Modification to run CPU09CMI on 5MHz bus.
Read FLPMIN_M.

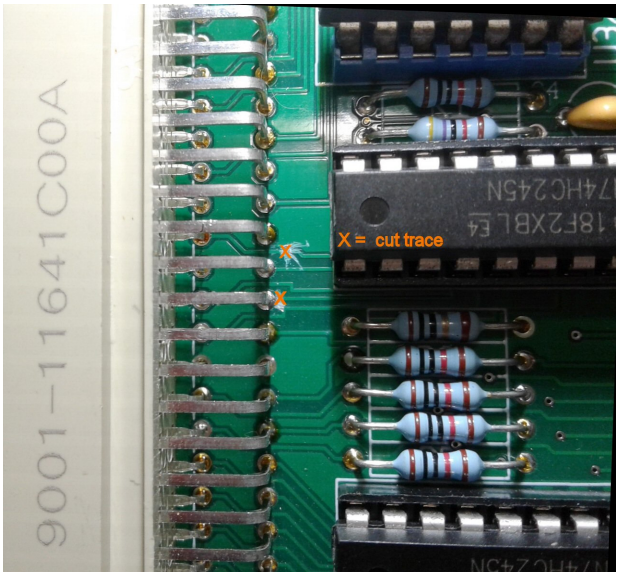
Replace xtal into 20MHz.
Replace C1 and C2 by 15pF.
Place 10M smd between crystal pins.
Replace GAL CMI_1 by CMI-4_1
Only use the HD63C09.

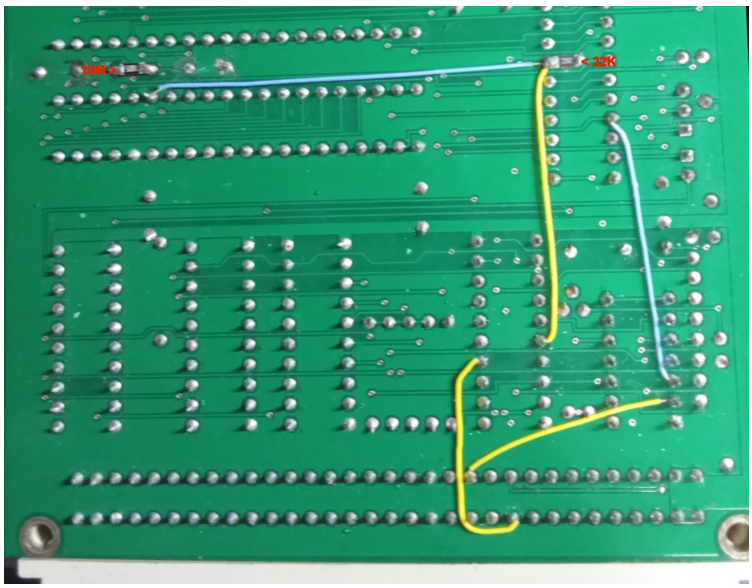
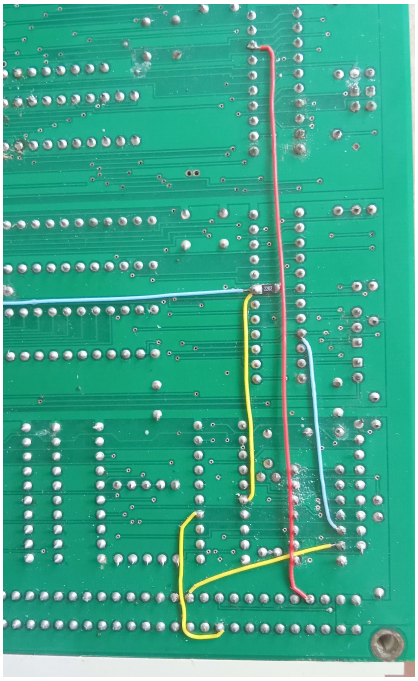
On top side:
Cut trace between U4-14 and J1 C-21 (B_VMA-)
For REV:0.9 print only cut trace from J1 A23 to R15

On solder side:
Cut trace between U13-19 and via (OVMA-)
Place 22K resistor between U13-19 and Gnd
Place wire from U6-35 to U13-19 (blue) and U4-6 (Q) (yellow)
Place wire from U4-14 to J1 A-23 (B_Q) (yellow)
>> Place wire from U14-18 to J1-C29 (red) >>

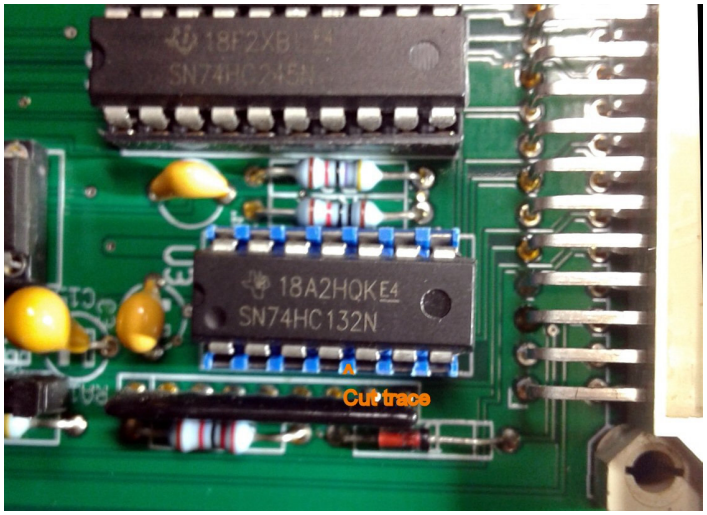
Place wire from U3-7 to J1 C-21 (B_VMA-) , **Or:**
To keep CPU09CMI 68x02 compatible
or need VMA- signal with 68x02 on the bus
for CPU09GPP or CPU09RAM card.

On top side:
Cut trace between U3-4 and U3-5

On solder side:
Place wire from U3-5 to U13-9 (VMA) (blue)
Place wire from U3-6 to J1 C-21 (B_VMA-) (yellow)
